**SOLICITATION AMENDMENT
MODIFICATION DE L'INVITATION**

| Title - Sujet Reconstruction de l'atelier de rech Reconstruction de l'atelier de recherche et sauvetage de la GCC de Kitsilano | |
| Solicitation No. - N° de l'invitation F521A-210639/A | Amendment No. - N° modif. 002 |

Kitsilano CCG SAR – Workshop Reconstruction Addendum #1

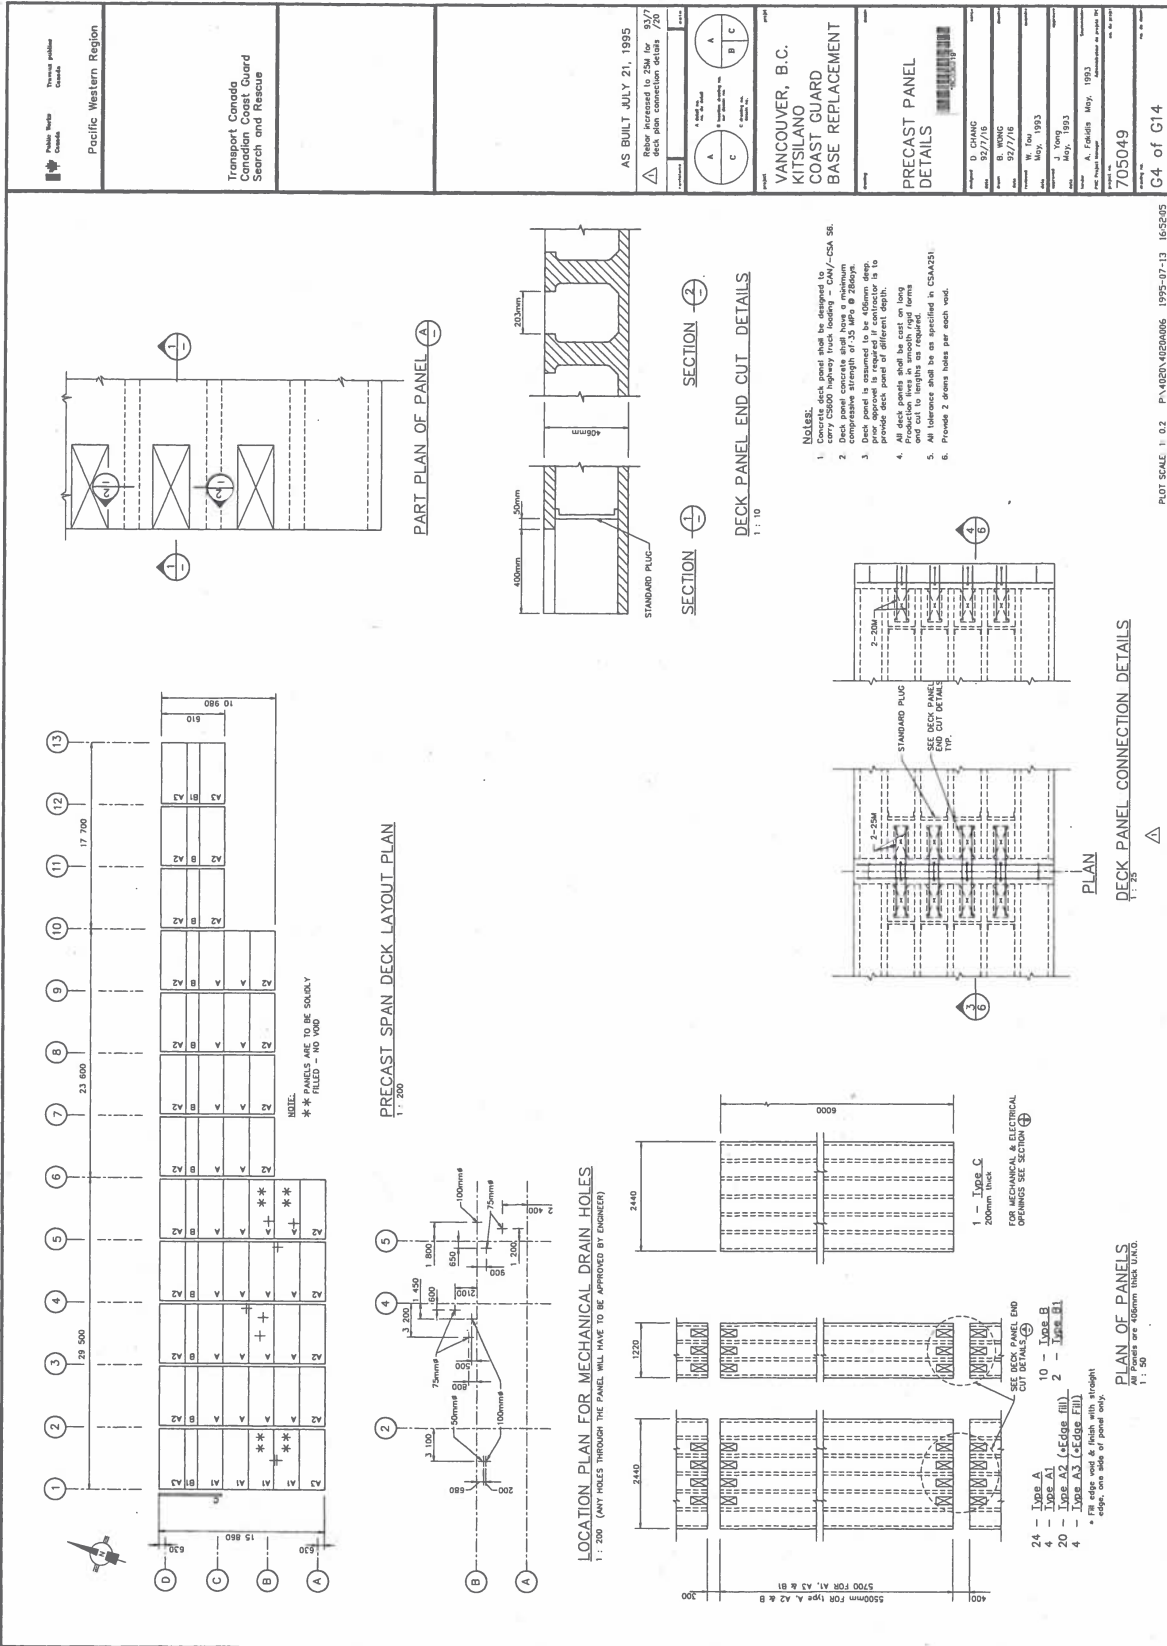
1. What is the thickness of the concrete slab at the Wharf

The concrete slab at the wharf consists of 406mm thick precast panels with a 100mm thick cast-in-place topping slab. See Amendment #1 below.
